Eastern Area Planning Committee

Wednesday, 7th February, 2018 at 6.00 pm

UPDATE REPORT

Item No: (1) **Application No:** 17/03079/COMIND **Page No.** 25 - 41

Suite 6, Crescent House, Yonge Close, Eastleigh, SO50 9SX
 Tel: 02382 026300

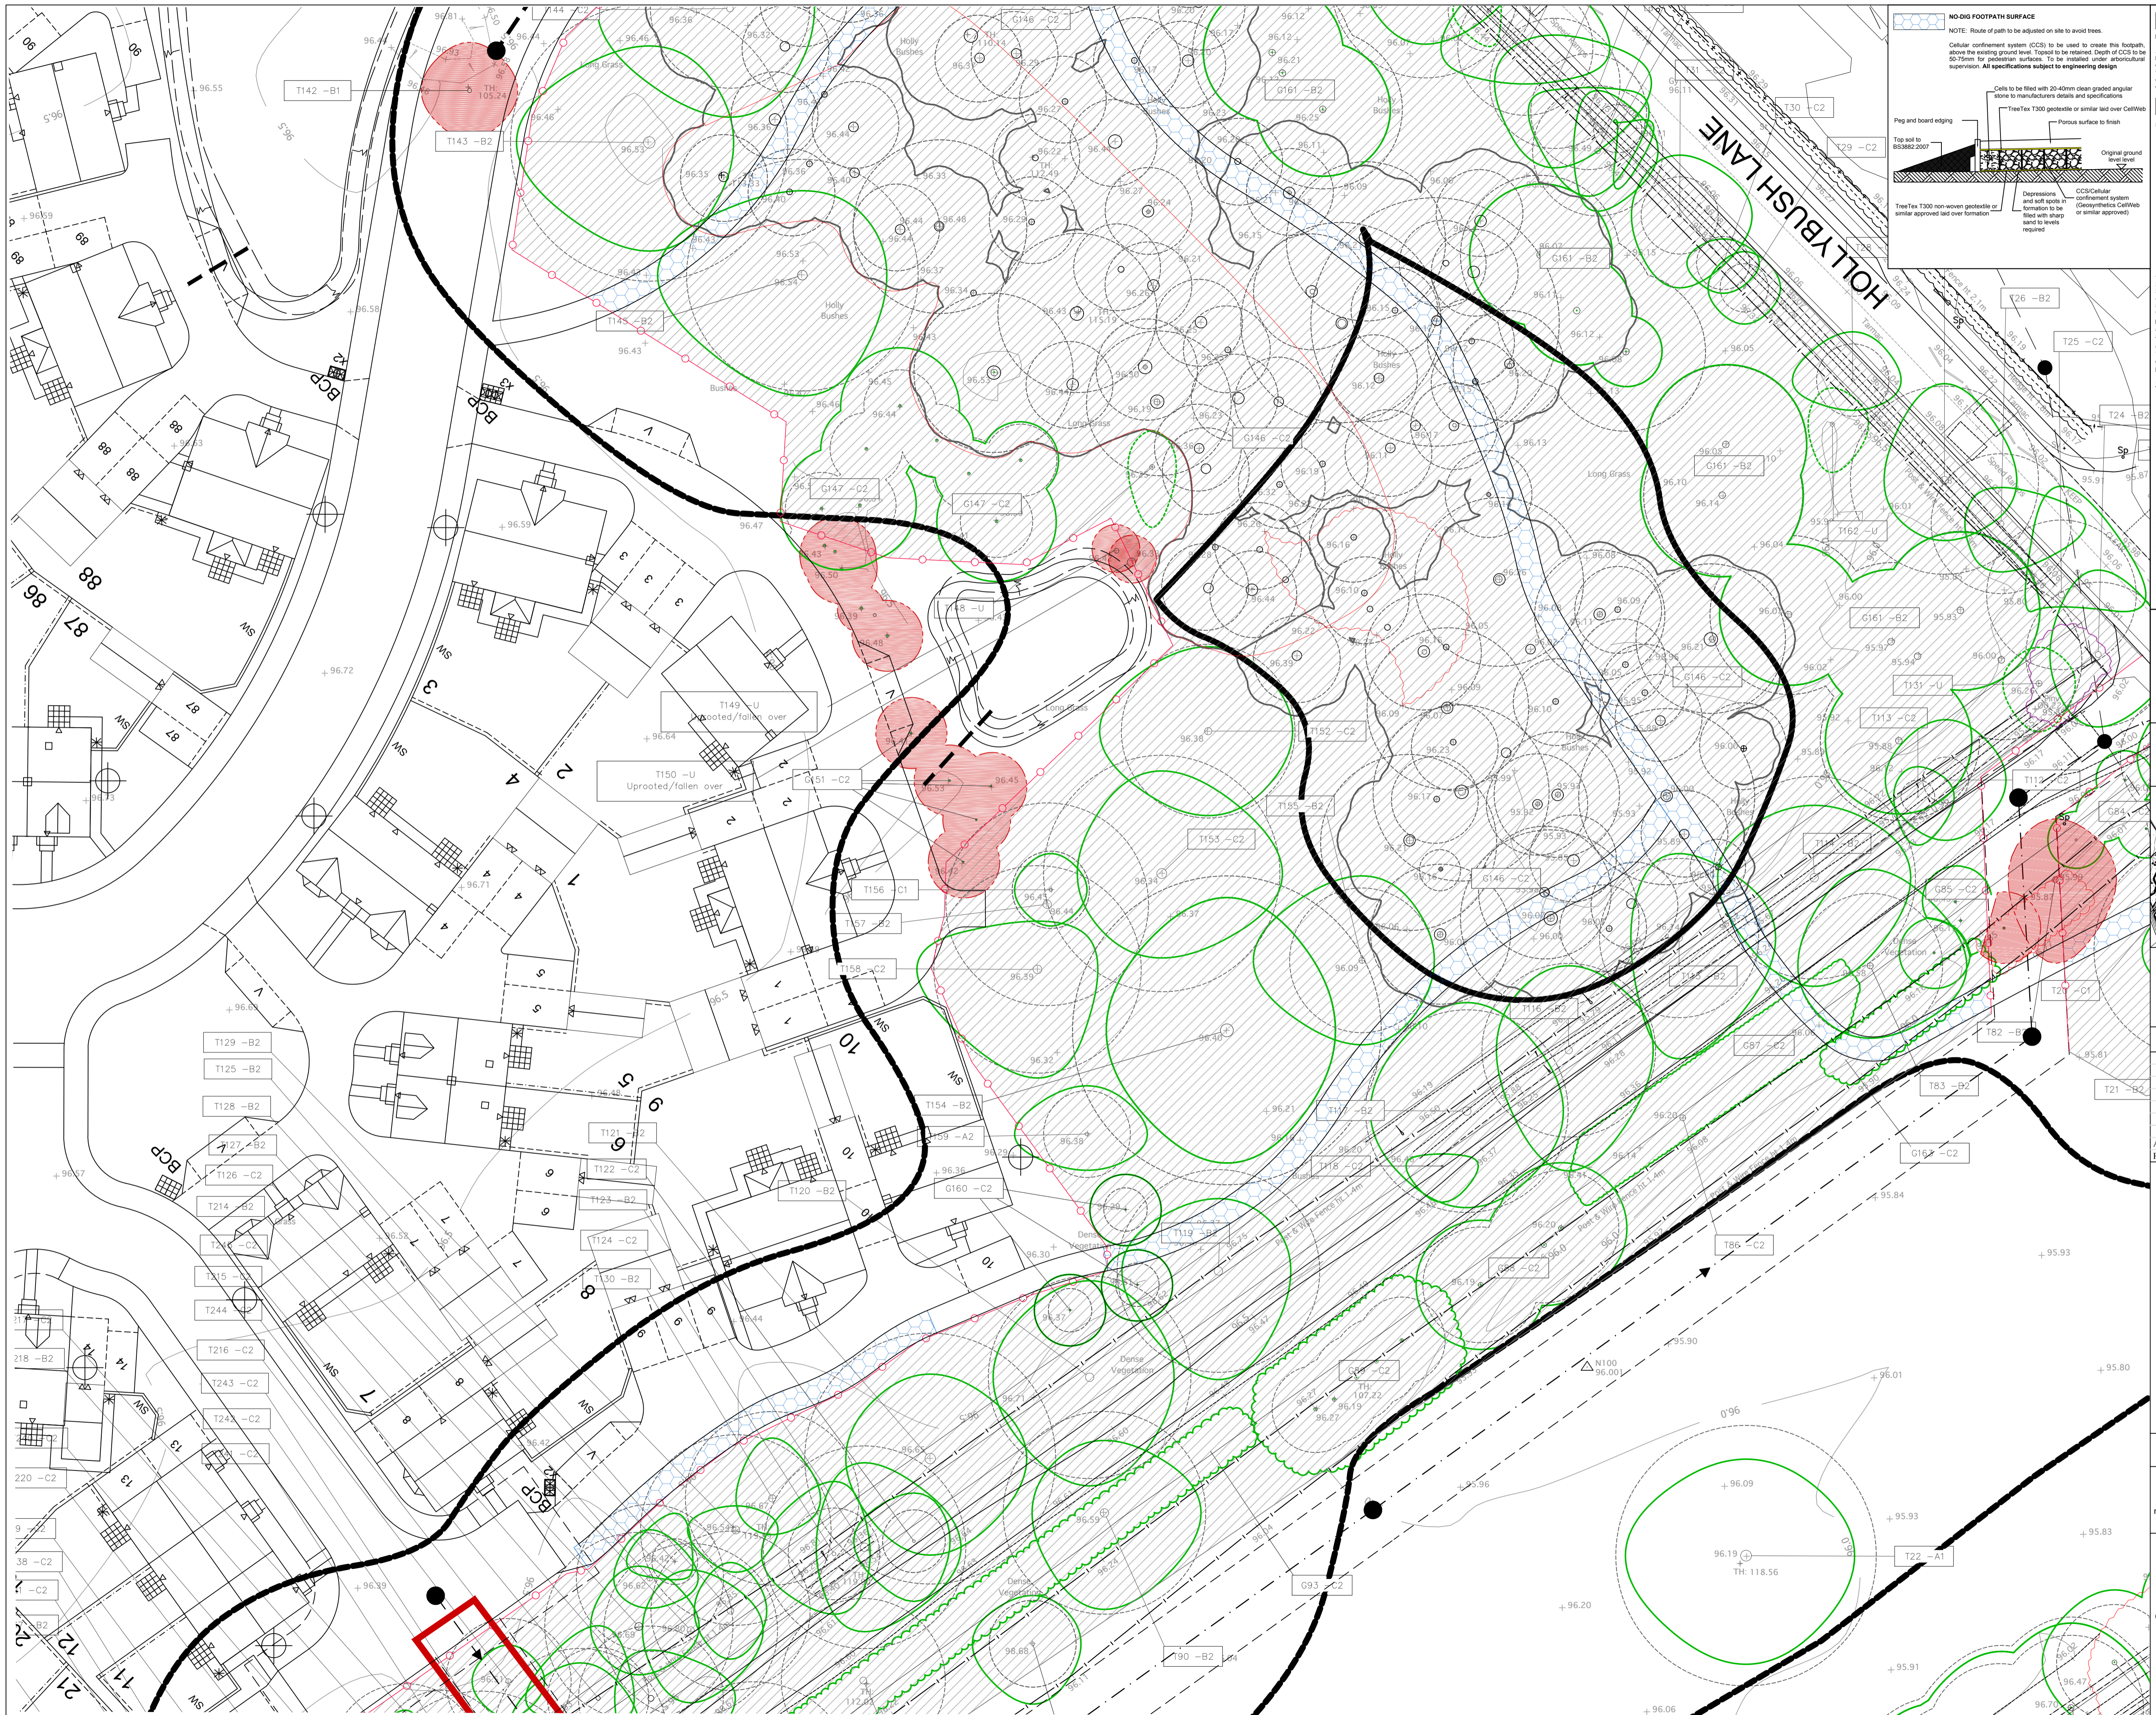
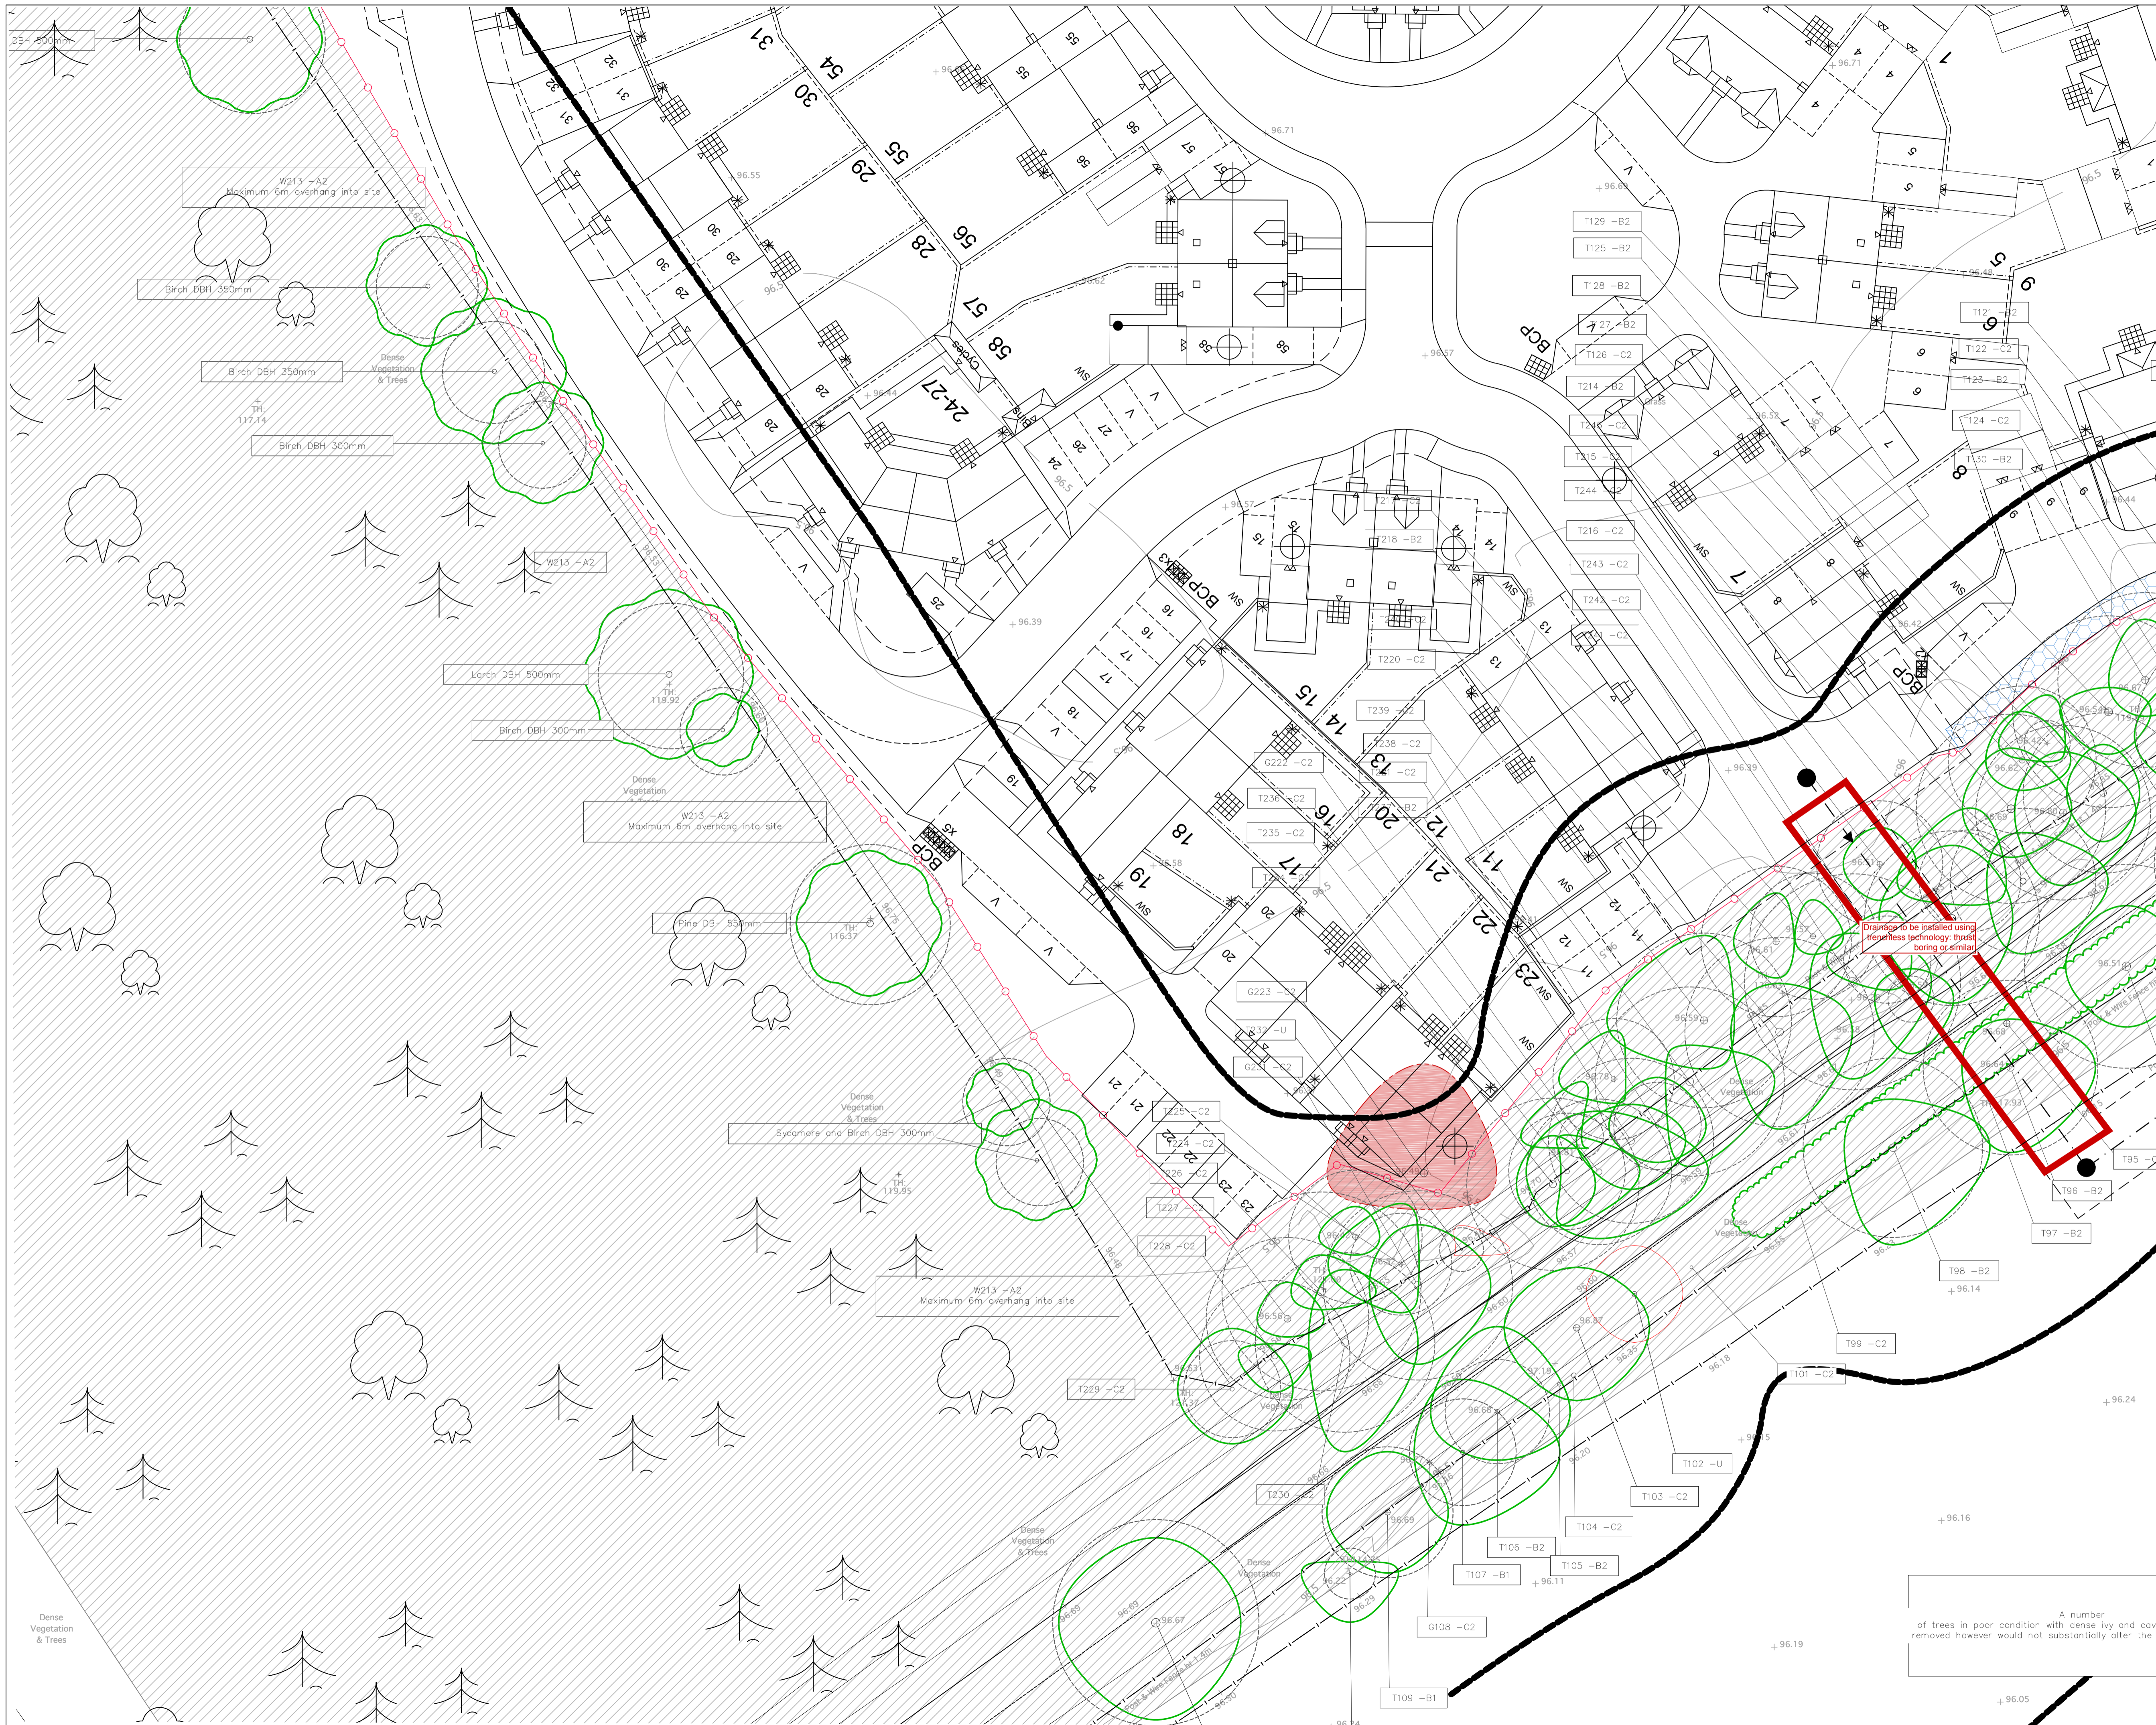
The approved drawings are attached showing the trees to be removed in red.
